REVISIONS	
B SIGNAL MODIFICATIONS	BA4945187
MJA/FAB

MD 45 (YORK ROAD) AT TIMONIUM ROAD

SIGNAL PLAN

DRAWING NO. TS-03 OF 04 SHEET NO. 13 OF 14

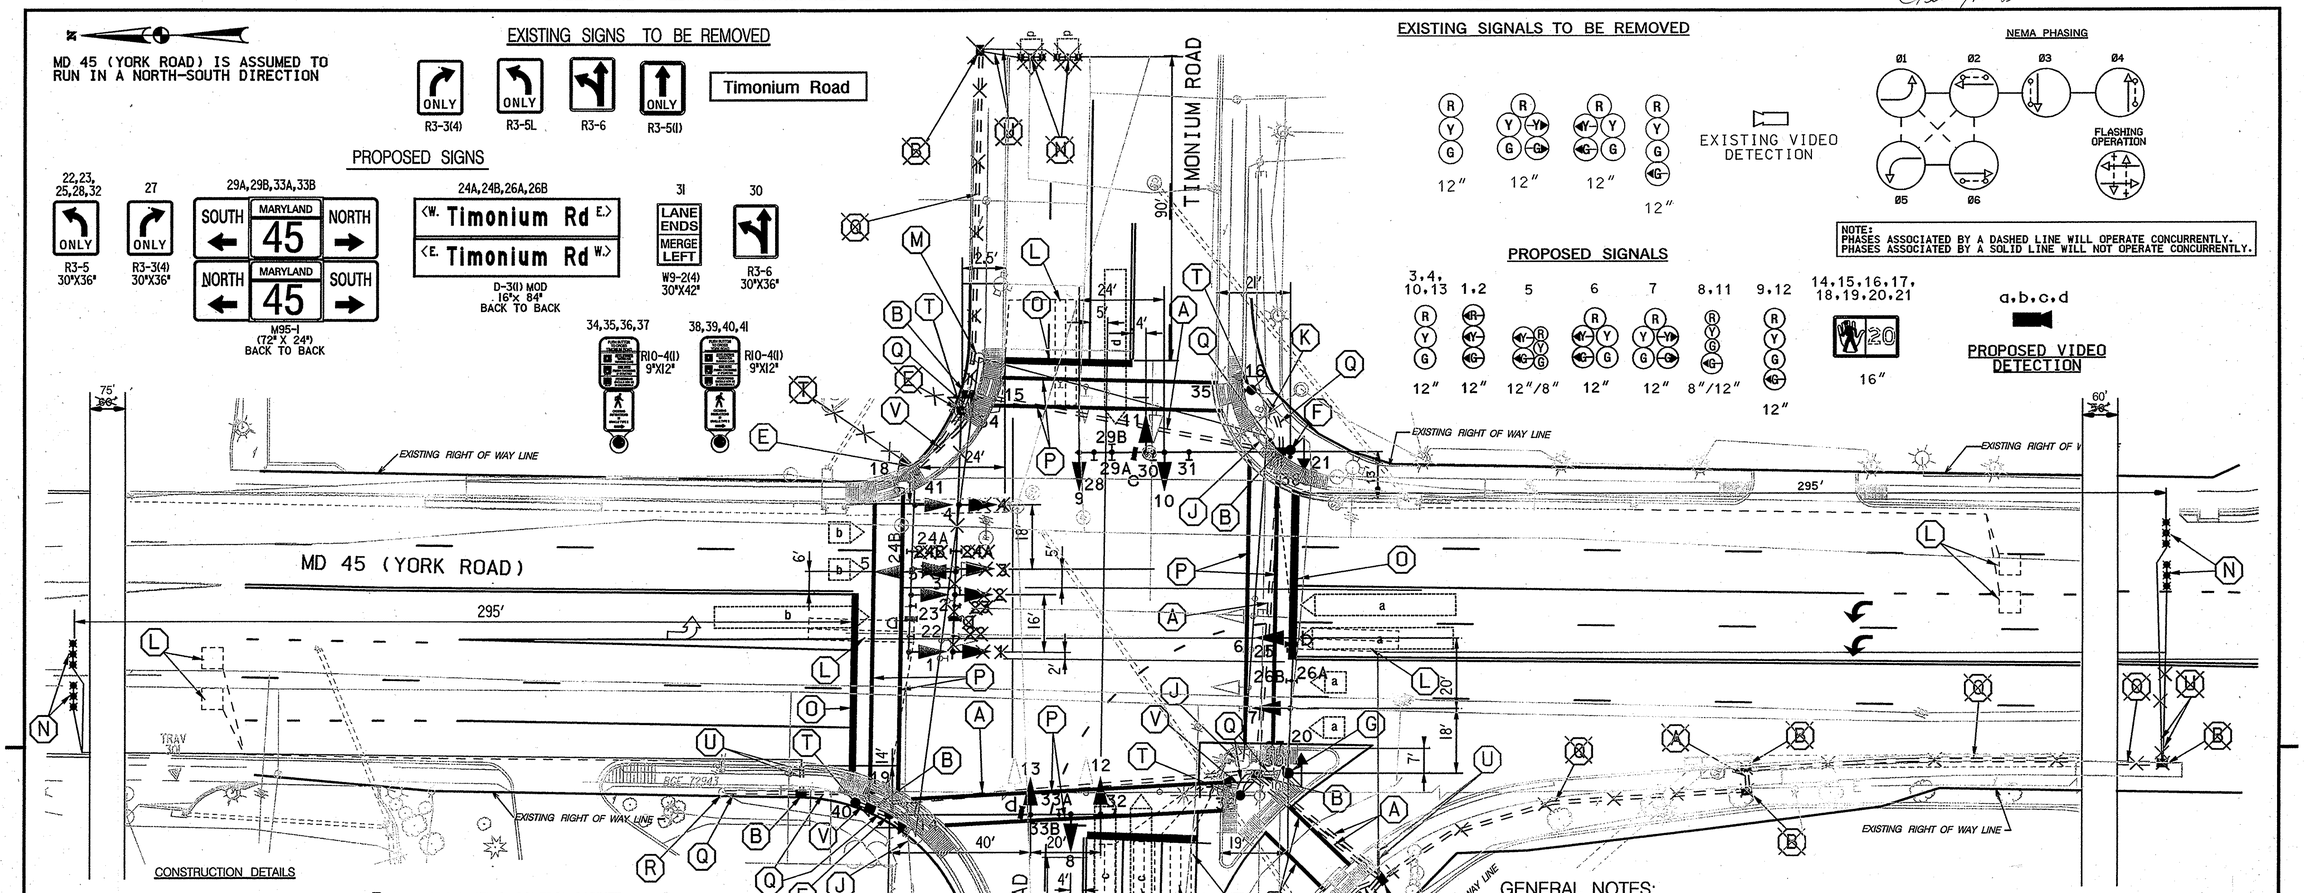
GREEN LINE - RELOCATED MICROPROBE LEAD-IN CABLES AND REVISED LOCATIONS OF SIGNAL POLE AND PEDESTRIAN POLE IN THE NORTHEAST QUADRANT OF THE INTERSECTION

- (F) INSTALL ~~36~~ 27 FT. ~~"X"~~ STEEL POLE WITH 50 FT. MAST ARM, TRAFFIC SIGNAL HEADS, PEDESTRIAN SIGNAL HEADS, SIGNS AND VIDEO DETECTION CAMERA. (NOTE 1-3 INCH SCHEDULE 80, 90 DEGREE PVC BEND IN POLE BASE). CUT POLE SO THAT REQUIRED CLEARANCES TO UTILITIES ARE MAINTAINED.
